ECE/TRANS/WP.29/GRE/2006/28
23 January 2006

PROPOSAL FOR DRAFT AMENDMENTS TO REGULATION No. 48

(Installation of lighting and light-signalling devices)

Transmitted by the experts from the Netherlands and Germany

Model A

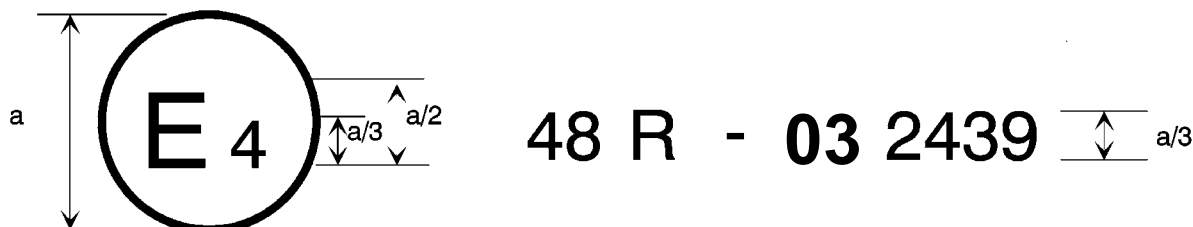
The above approval mark affixed to a vehicle shows that the vehicle type concerned has, with regard to the installation of lighting and light-signalling devices, been approved in the Netherlands (E4) pursuant to Regulation No. 48 as amended by the ~~02~~ **03** series of amendments. The approval number indicates that the approval was granted in accordance with the requirements of Regulation No. 48 as amended by the ~~02~~ **03** series of amendments.

The same justification as for paragraph 4.2.

Model B

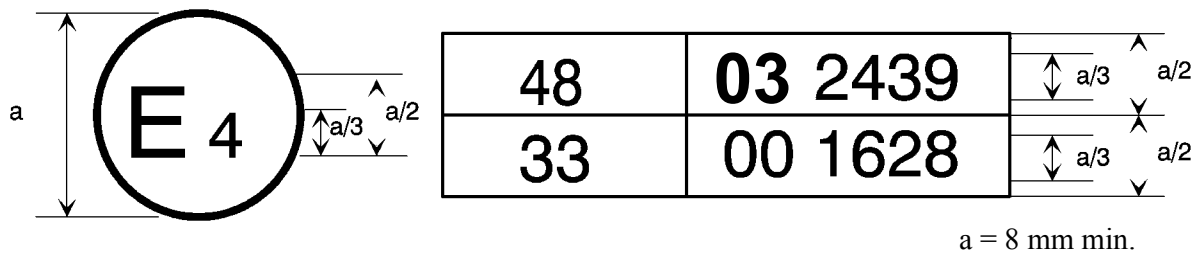
The above approval mark affixed to a vehicle shows that the vehicle type concerned has been approved in the Netherlands (E4) pursuant to Regulation No. 48 as amended by the ~~02~~ **03** series of amendments and Regulation No. 33. ^{1/} The approval number indicates that, at the dates when the respective approvals were given, Regulation No. 48 was amended by the ~~02~~ **03** series of amendments and Regulation No. 33 was still in its original form.
